**LOWER GWYNEDD TOWNSHIP
PLANNING COMMISSION
MEETING AGENDA
September 16, 2026
Public Meeting**

Reference: Gwynedd Mercy Academy High School
Parking Expansion – Waiver of Land Development

RE: **Traffic Review – Waiver of Land Development Plans**
Gwynedd Mercy Academy High School – 1345 Sumneytown Pike
Lower Gwynedd Township, Montgomery County, PA
Project No. 314087-01-029

Reference: 813 Plymouth Road
TMP #39-00-03589-00-8
Minor Subdivision Plan

Sheet No:	Sheet No:
1 of 4	PARKING AREA EXPANSION LAYOUT PLAN
2 of 4	GRADING & EROSION CONTROL PLAN
3 of 4	EROSION CONTROL SPECIFICATION & DETAILS
4 of 4	GENERAL CONSTRUCTION DETAILS

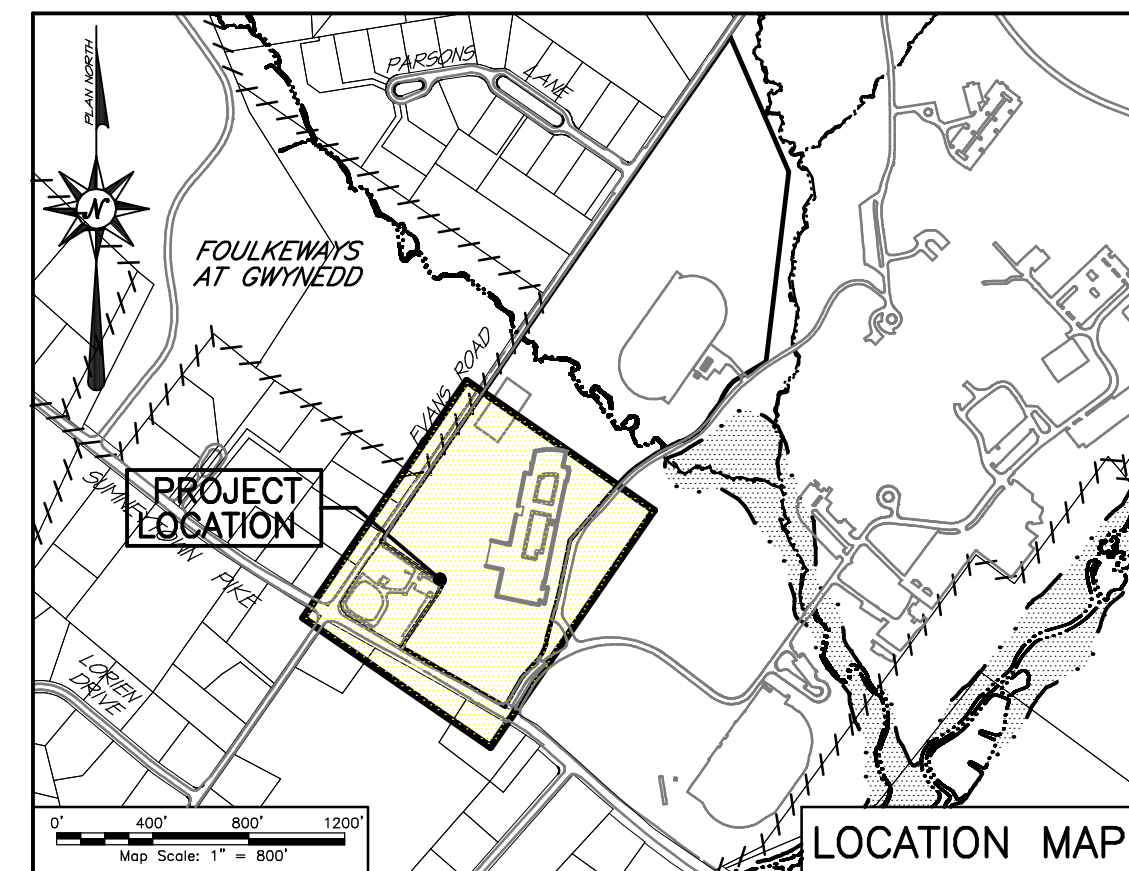
1. We note that the existing stormwater facilities appear to have enough capacity to control the runoff from the added impervious surface areas. The Applicant shall ensure that the peak rate requirements for the site are still satisfied with the additional flow.

2. It appears that the new spaces are immediately adjacent to the exiting spaces along the construction access drive. The applicant should consider the possibility of a planting strip between the two parking areas.

3. We note that the existing parking lot contains parking lot lights. However, it does not appear that any new lighting is proposed for this parking area. The Applicant shall discuss with the Board whether additional lighting is needed in the new parking area. In the event that it is determined that lighting is necessary, then a full lighting plan shall be submitted for review.

2. The existing "Stop" sign on the southbound approach of the eastern driveway leading to/from the parking area on the southwestern corner of the school at its intersection with Reiley's Way should be shown on the plans. A stop bar should be added to the plans at this "Stop" sign location.

3. A "Stop" sign and stop bar should be shown on the plans at the following locations:
 - On the northbound approach of the drive aisle leading to/from the existing parking area to the west of the proposed parking area at its intersection with the drive aisle to the south of Reiley's Way.

4. A stop bar should be shown on the plans at all existing and proposed "Stop" sign locations throughout the site.
 5. The proposed development is subject to the Transportation Impact Fee of \$3,865 per "new" weekday afternoon peak hour trip. The applicant must confirm whether the proposed site modifications are expected to generate additional trips to/from the site during the weekday afternoon peak hour.

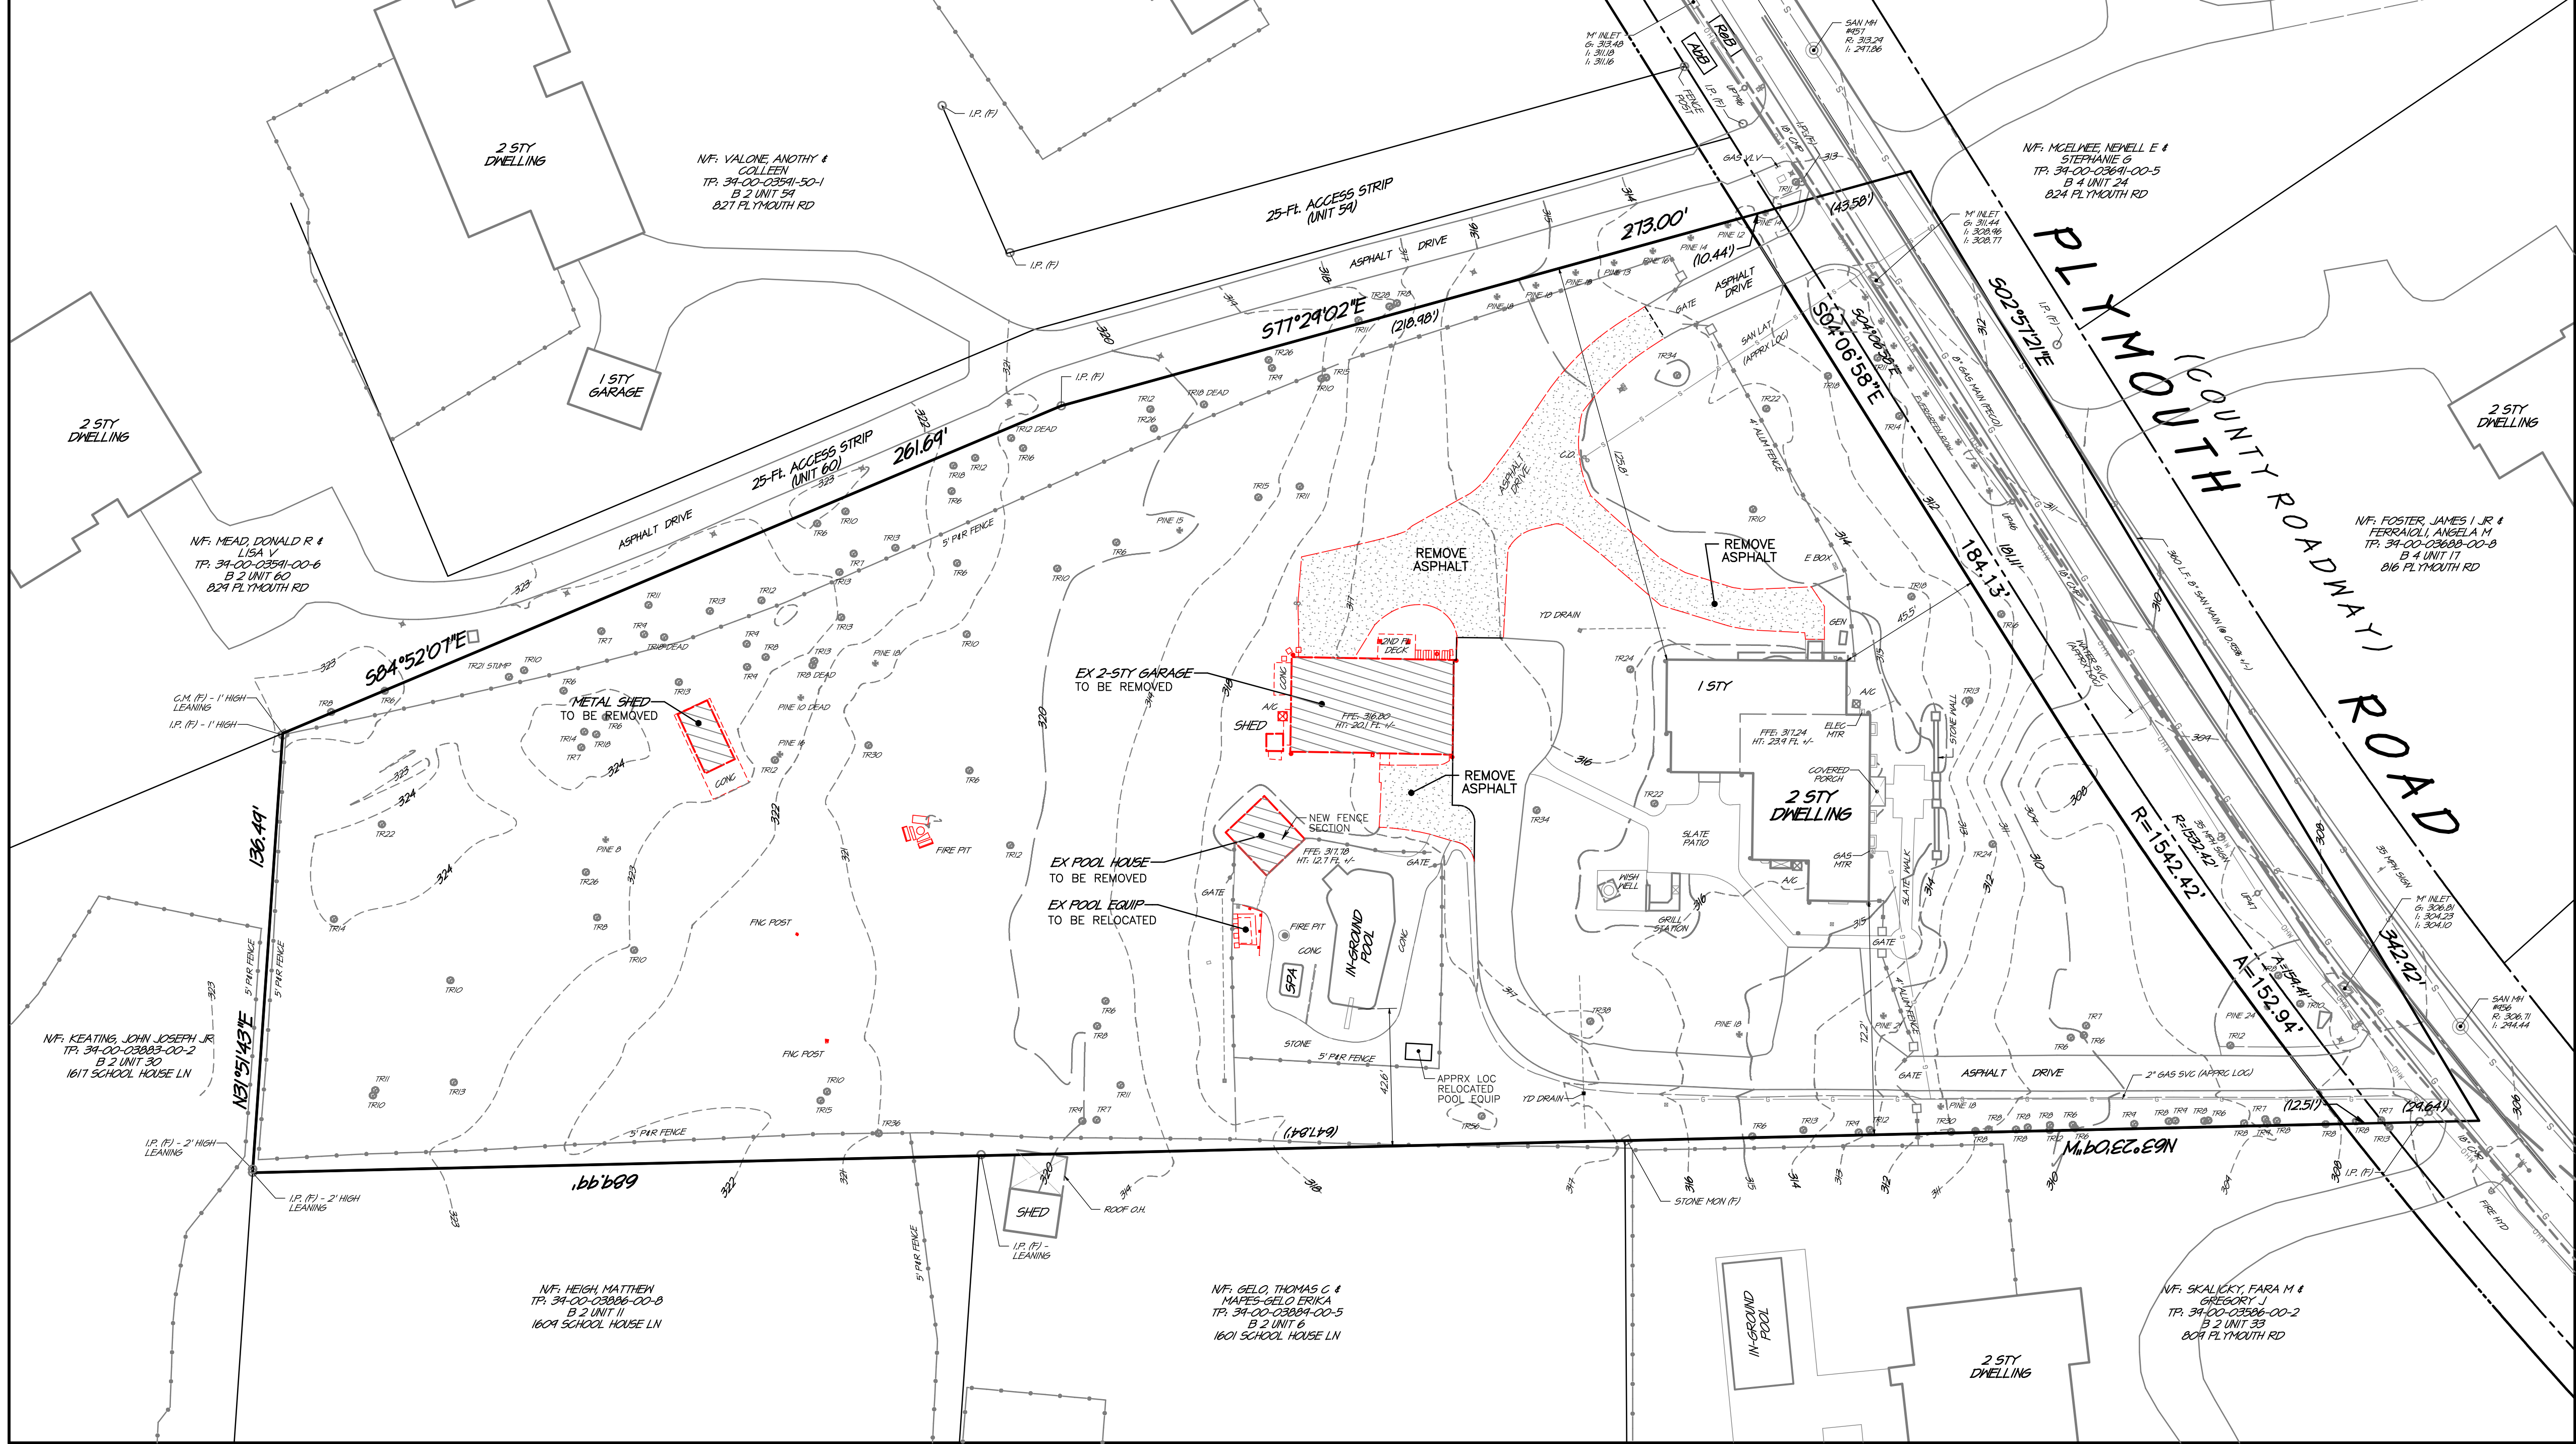
1. §1257.03(a)(3) – Where both a public sewer and a public water supply are available, a lot area of not less than 40,000 square feet shall be provided for every dwelling or other building. Whenever public sewer or public water supply is available, connection to the public utility is required as a condition of this subsection. We note that the Applicant intends to utilize the 40,000 square foot lot minimum for the proposed subdivision. However, the plans do not indicate whether the existing lot is currently connected to public water. If the current property is not connected, then a proposed connection will be required with this application.

2. §1298.21(e) – A driveway serving a flag lot shall have a minimum stabilized width of 20 feet and a paved width of 16 feet for its entire length. We note that it appears that the applicant plans to utilize the existing driveway access for the new lot. However, the existing driveway appears to be roughly 12 feet in width and the existing gate is approximately 16 feet in width. We note that the Applicant will be required to widen the driveway. Additionally, we defer to the Fire Marshal regarding the existing width of the gate for emergency vehicles.

7. §1230.37 (c), (d) & (e) – Plymouth Road is classified as an intercommunity road, which requires an 80-foot Ultimate right-of-way and a minimum of 34-foot cartway. We note that the plans appear to meet the 40-foot halfway width for the ultimate right-of-way, however, the applicant will be required to provide additional cartway width or a waiver would be required.

1. According to **Section 1230.37(c)** of the **Subdivision and Land Development Ordinance**, Plymouth Road should have a minimum cartway width of 34 feet. The plans currently show an approximate 28 to 30-foot cartway width along the Lot A and Lot B site frontages of Plymouth Road.

2. Sight distance measurements should be shown on the plans at the driveway locations for Lot A and Lot B along Plymouth Road as required in **Section 1230.38(a)** of the **Subdivision and Land Development Ordinance**.

3. According to **Section 1230.45(a)** of the **Subdivision and Land Development Ordinance**, sidewalk is required along both sides of all existing and new streets. The plans currently do not show any sidewalk along the Lot A and Lot B site frontages of Plymouth Road.

4. According to **Section 1230.61(a)** of the **Subdivision and Land Development Ordinance**, curbing is required along both sides of all existing and proposed streets. The plans currently do not show any curbing along the Lot A and Lot B site frontages of Plymouth Road.

5. According to **Section 1298.21(e)** of the **Zoning Ordinance**, a driveway serving a flag lot shall have a minimum paved width of 16 feet for its entire length. The plans show an approximate 12-foot width along the existing northern driveway that will provide future access to Lot B.
